Re: *Addendum No. 2*
Woods Ridge Elevated Water Storage Tank
Scioto County Regional Water District No. 1

Date: April 15, 2025

SCIOTO COUNTY REGIONAL WATER DISTRICT NO. 1 WOODS RIDGE ELEVATED STORAGE TANK SCIOTO COUNTY LUCASVILLE, OHIO	SITE IMPROVEMENTS - 01 SERIES	
	WATER STORAGE TANK DETAILS

PROJECT NO.	
241842	
DISCIPLINE	
CIVIL	
SHEET NAME	
01C-04	
SHEET	OF
6	8

NOTE:
1. TANK APPURTENANCES SHOWN MAY BE SHOWN OUT OF SECTION. REFER TO TANK SITE PLAN FOR ACTUAL ORIENTATION OF APPURTENANCES.

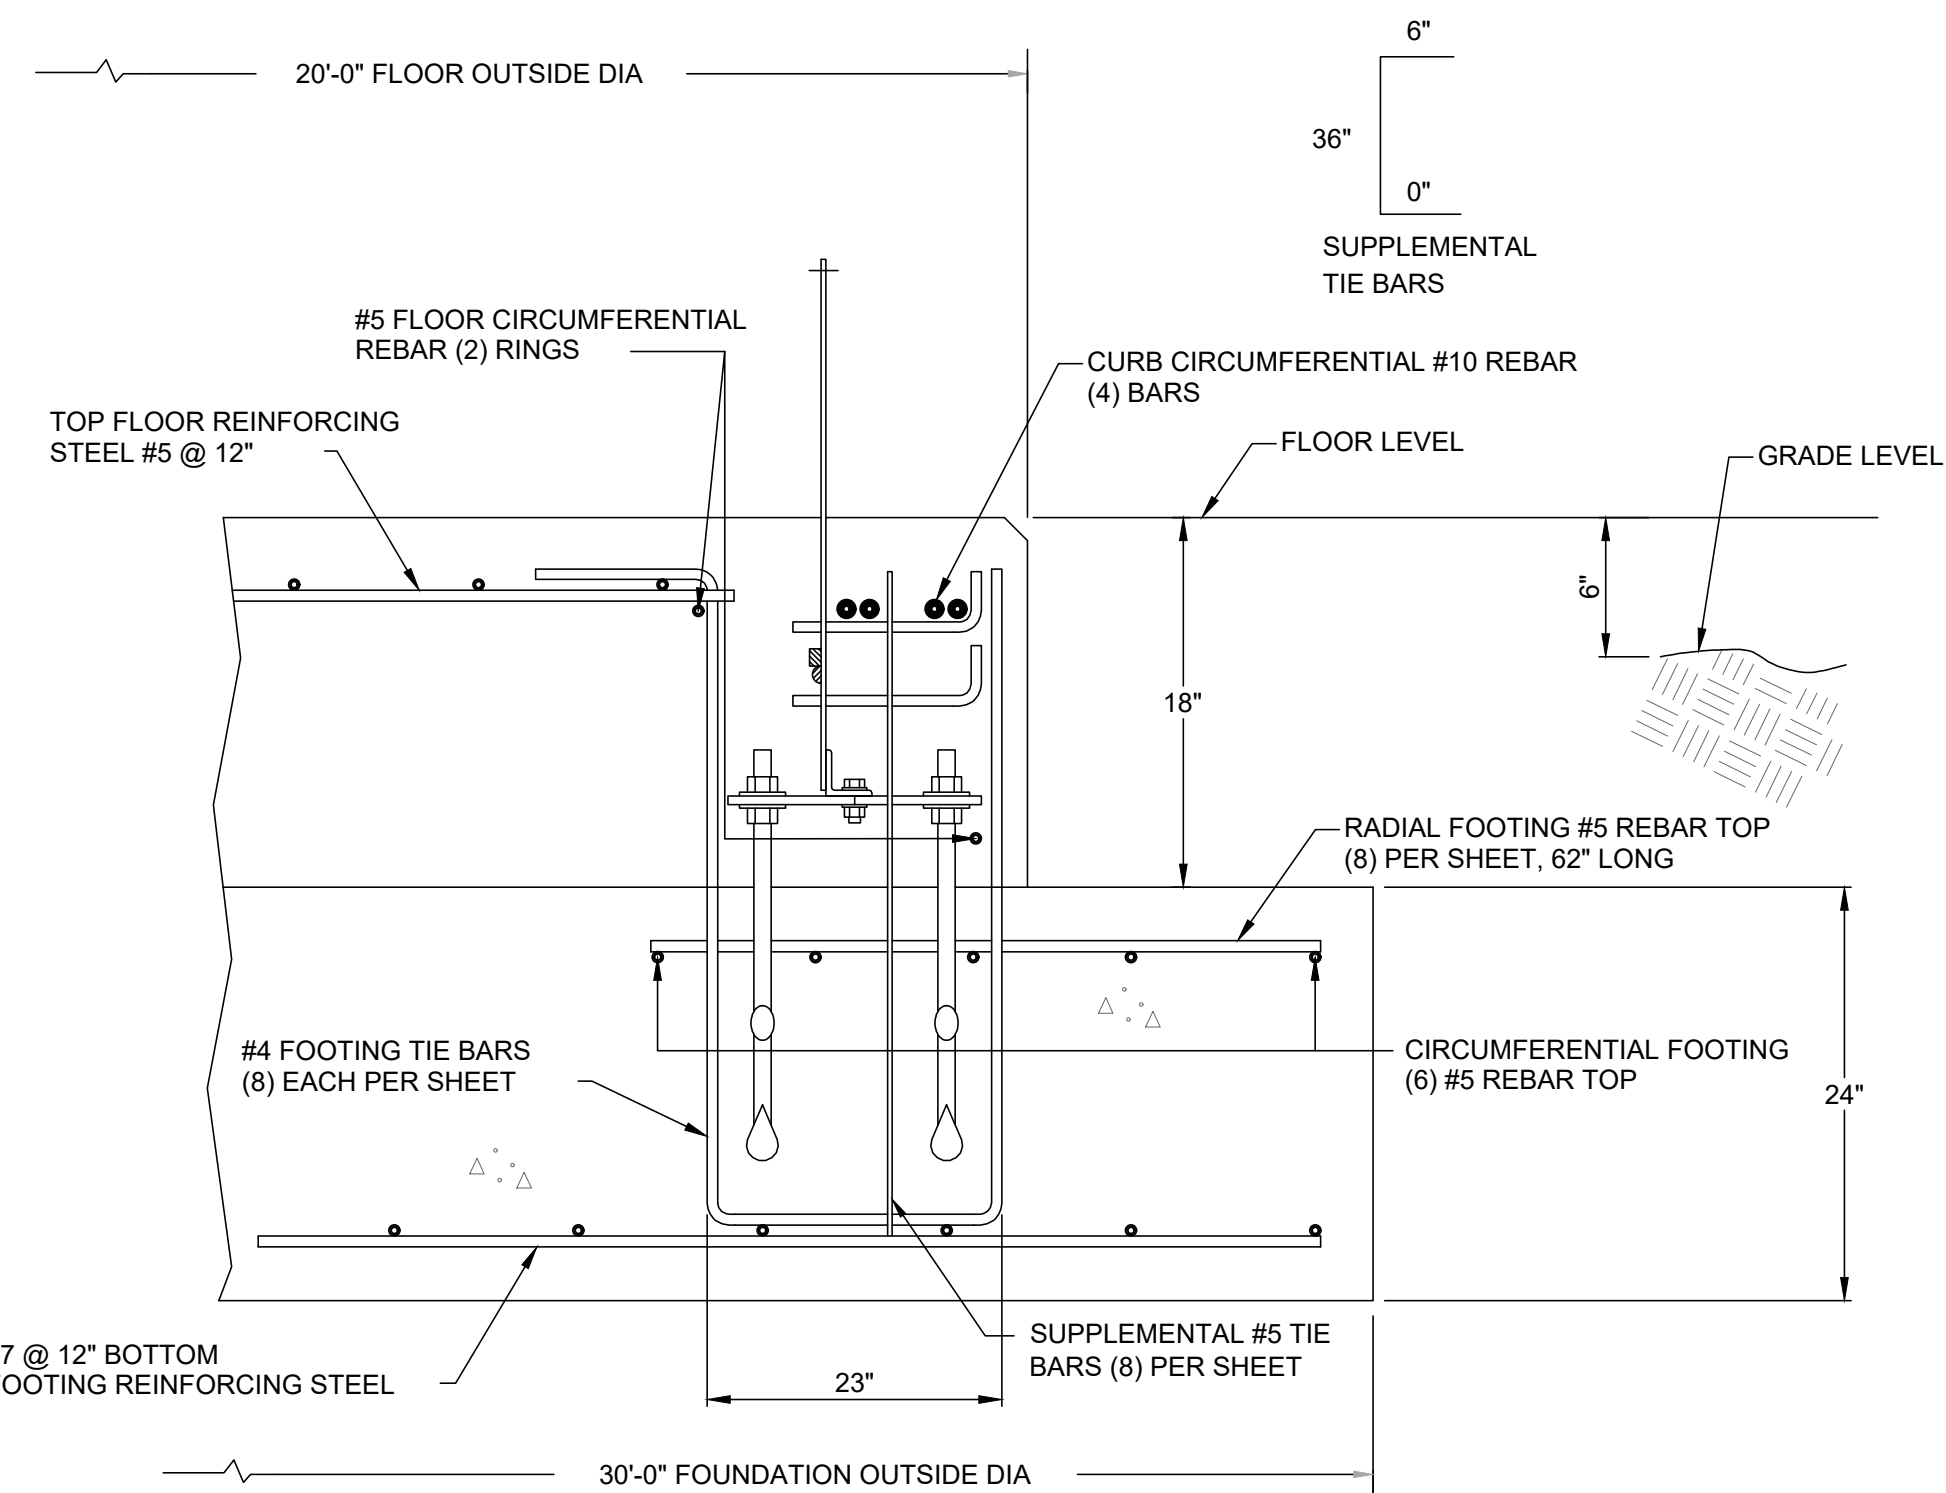
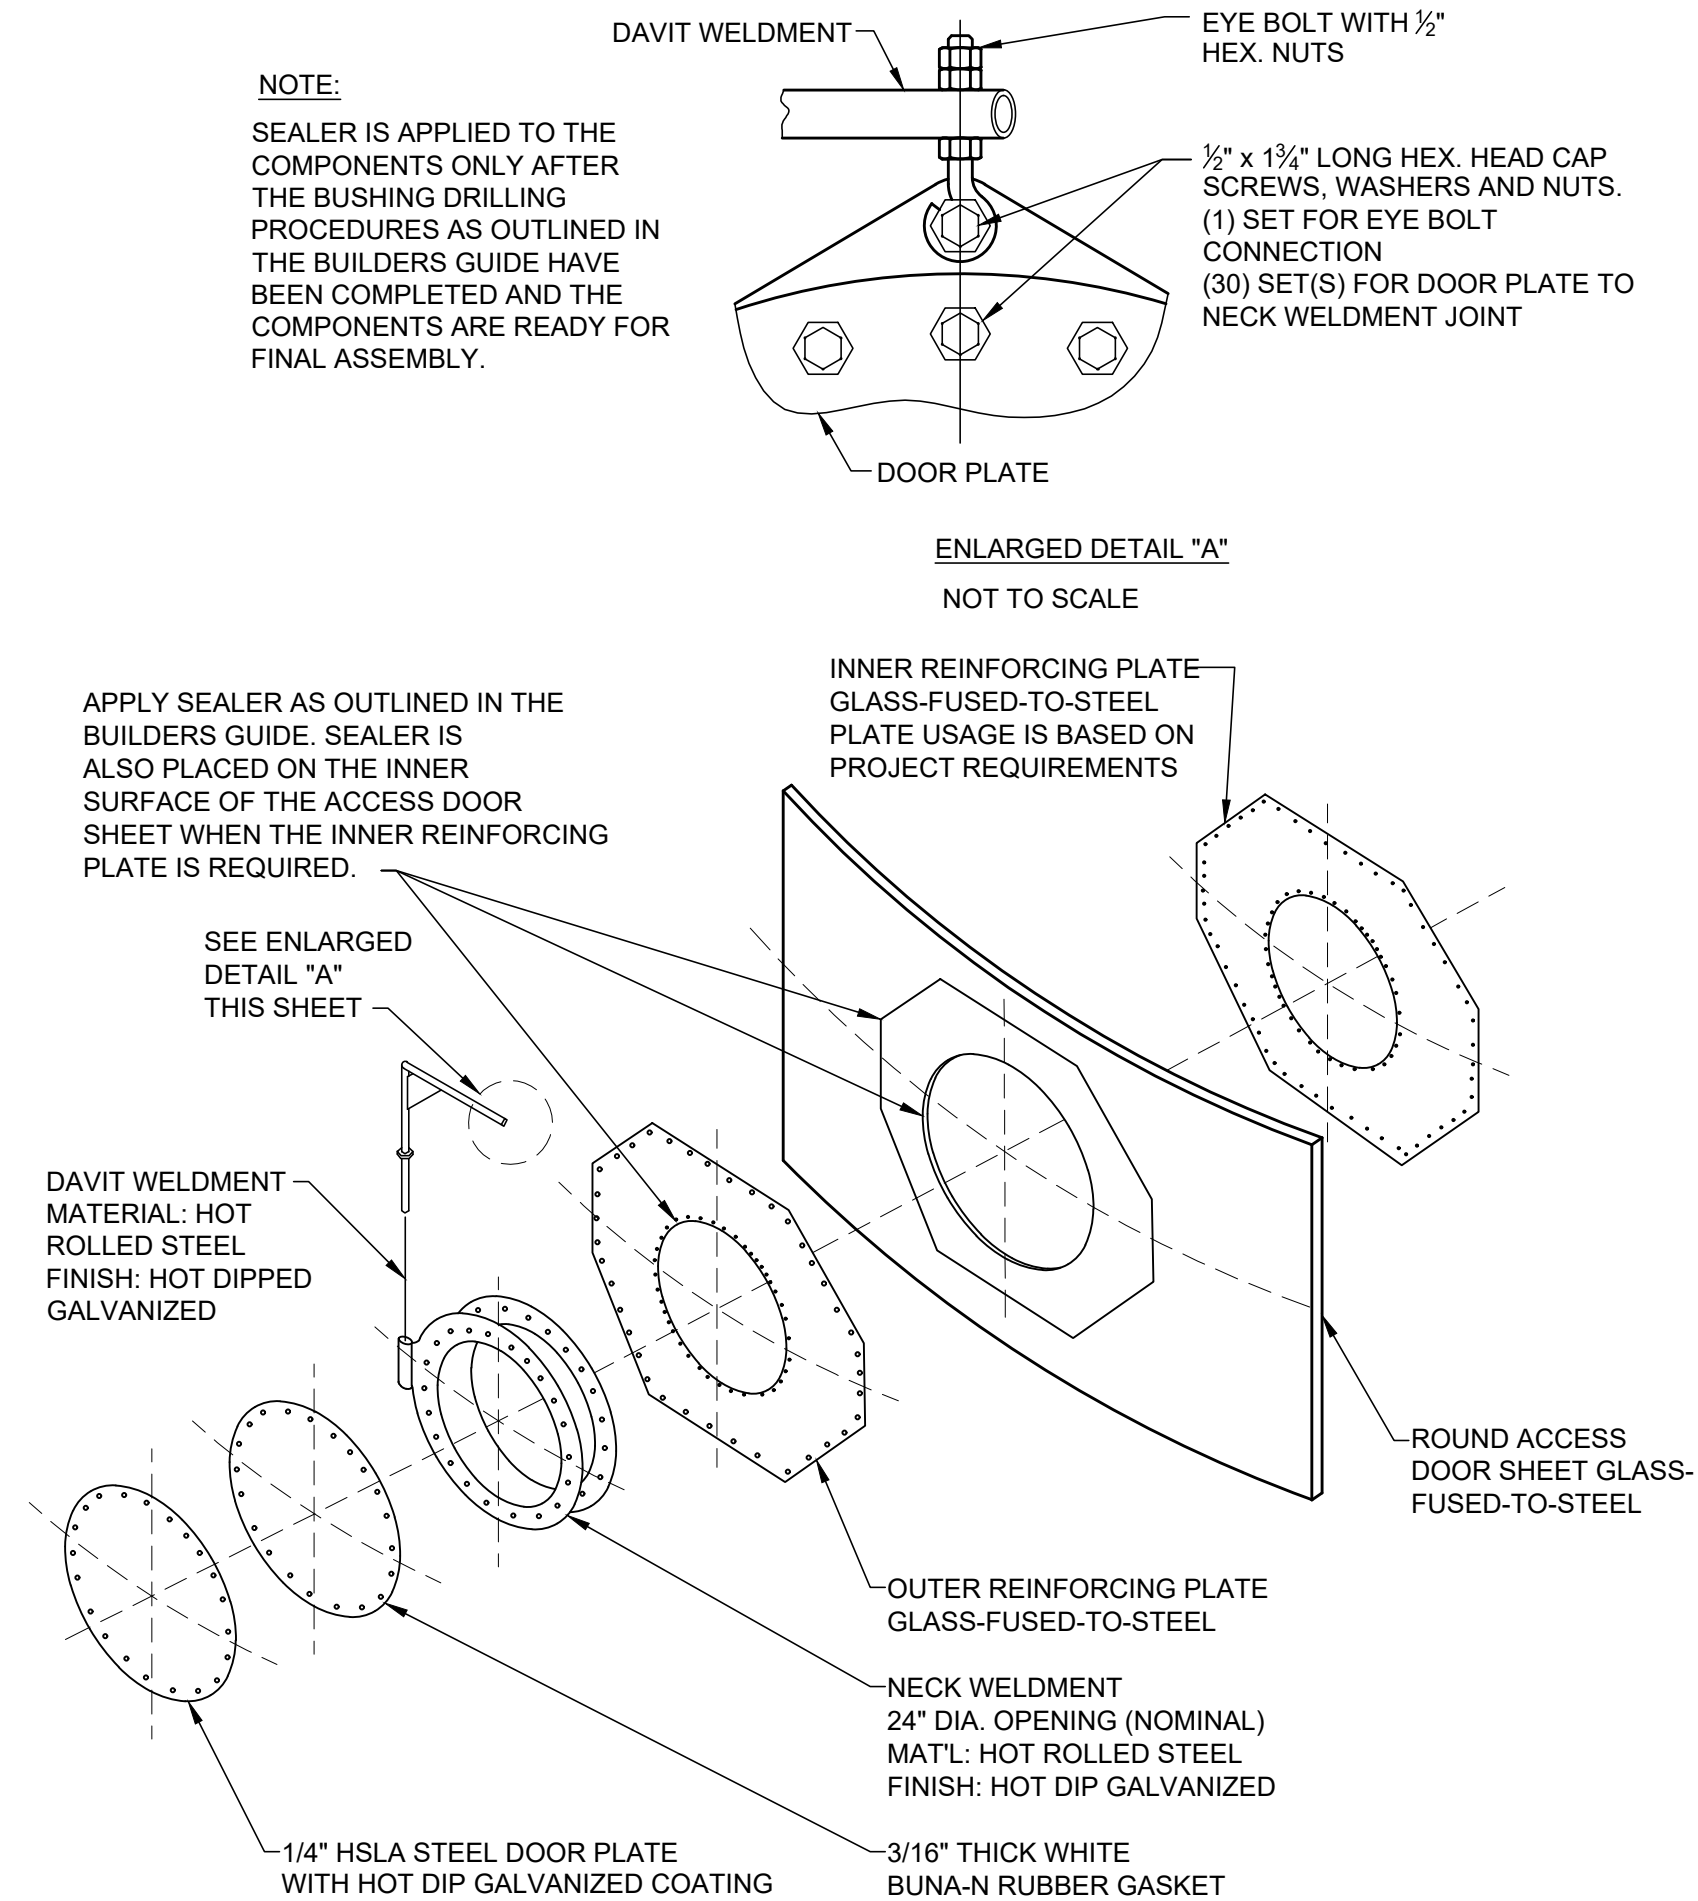
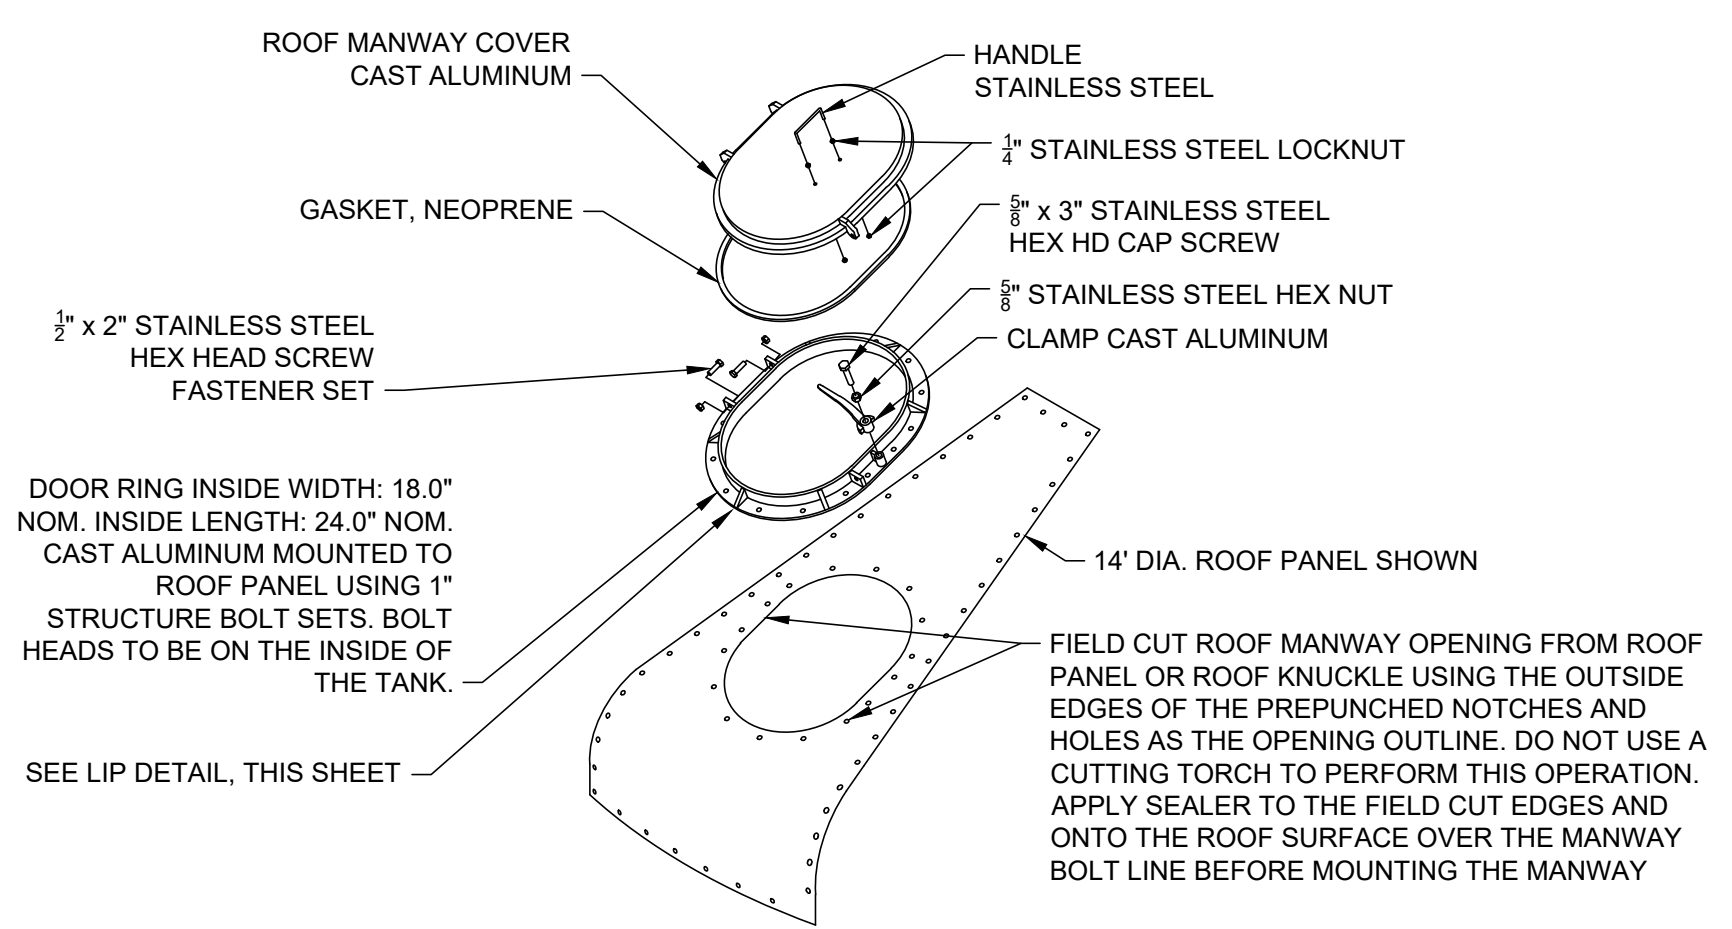
5. SHEET 6 of 8, 01C-04 – WATER STORAGE TANK PLAN & SECTION

REPLACE this drawing in its entirety with the revised drawing attached to this addendum.

ROOF HATCH DETAIL
NOT TO SCALE

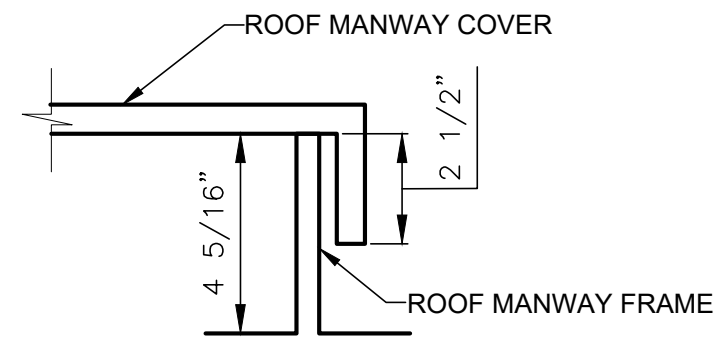
- a. **REPLACE** Paragraph 2.1.B.14. b. in its entirety with the following text:

“A 24-inch x 18-inch minimum diameter hinged roof hatch with padlock bracket shall be located adjacent to the roof access walkway. The opening shall have a curb four inches high, and the cover shall have a downward overlap of 2 inches.”

CONSTRUCTION DETAIL
GRAVITY VENTILATOR
INSTALLATION ONTO ROOF
CAP 20° SLOPED ROOF

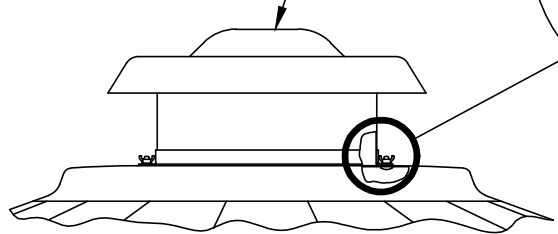
- k. **ADD** Paragraph 2.5.E. Roof Vent as follows:

“E. Roof Vent

1. A properly sized vent assembly in accordance with AWWA D103 shall be furnished and installed above the maximum water level of sufficient capacity so that at maximum possible rate of water fill or withdrawal, the resulting interior pressure or vacuum will not exceed 0.5" water column.
2. The overflow pipe shall not be considered to be a tank vent.
3. The vent shall be constructed of aluminum.
4. The vent shall be so designed in construction as to prevent the entrance of birds and/or animals by including an expanded aluminum screen (1/2 inch) opening. An insect screen of 23 to 25 mesh polyester monofilament shall be provided and designed to open should the screen become plugged by ice formation.”
